Subject: Insufficient clearance between coolant hose and right-hand inner fender splash shield on some Aeromaster models.

Condition: Coolant reservoir hose may rub against splash shield.

Applies To: This bulletin applies to model year 2019-2020 Aeromaster on the Ford F59 chassis, manufactured between January 1, 2019 and July 30, 2020. Contact Utilimaster Warranty Department to verify chassis VIN.

Correction: Secure hoses and trim rubber splash shield.

Overview of interference between RH inner fender splash shield and hose(s)

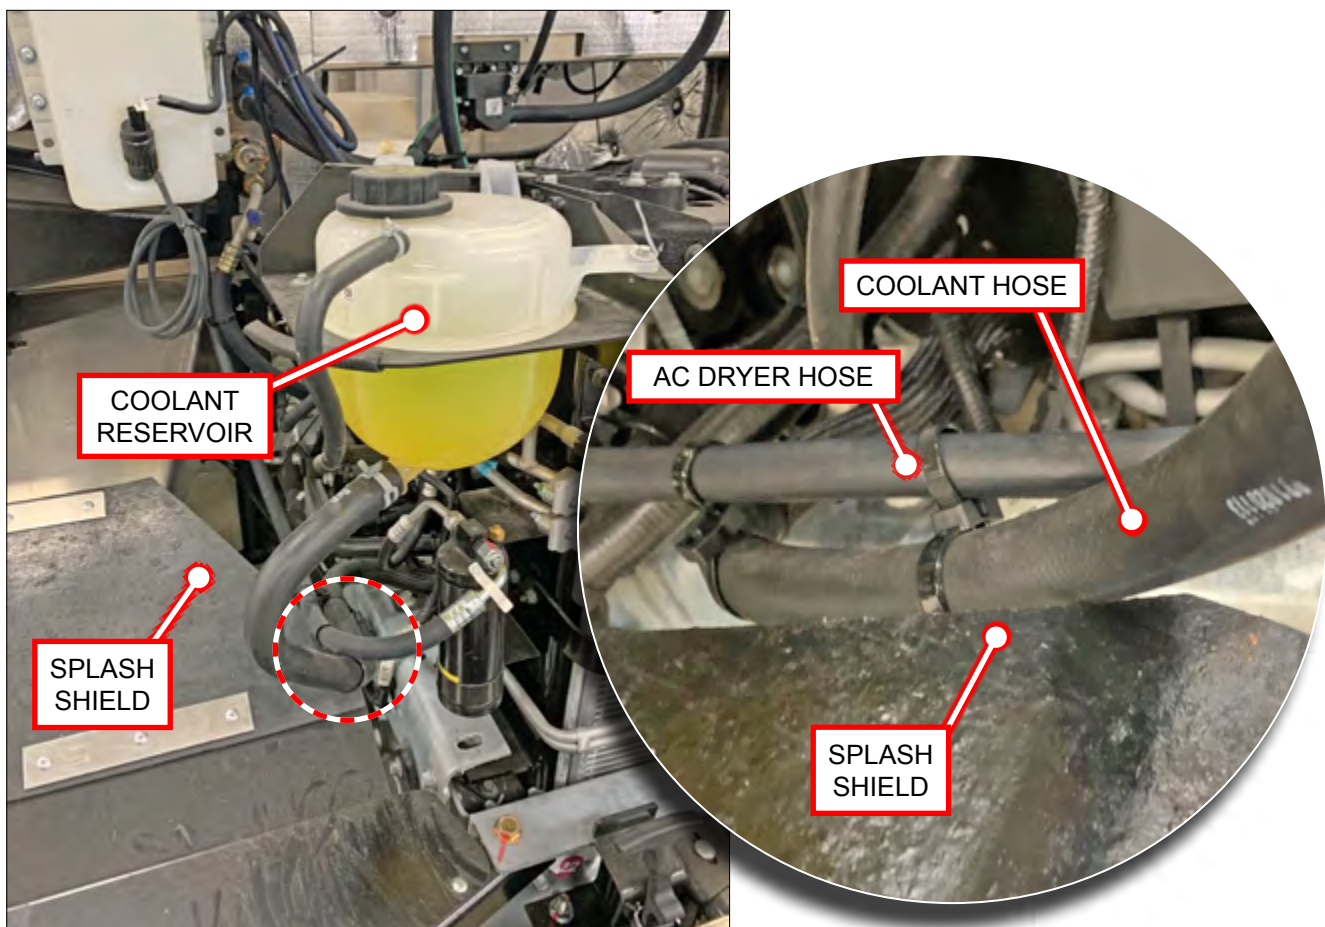
1. Read and understand all the instructions before starting the repair.
2. Raise the hood and visually inspect the lower coolant reservoir hose.
 - a. If there is at least 1" clearance between the rubber splash shield and the hoses, no further action is needed.
 - b. If coolant overflow hose has less than 1" clearance and there is no hose abrasion, proceed with Splash Shield Trim Procedure.
 - c. If coolant overflow hose shows sign of damage, proceed with Splash Shield Trim Procedure and follow the Hose Repair Procedure.
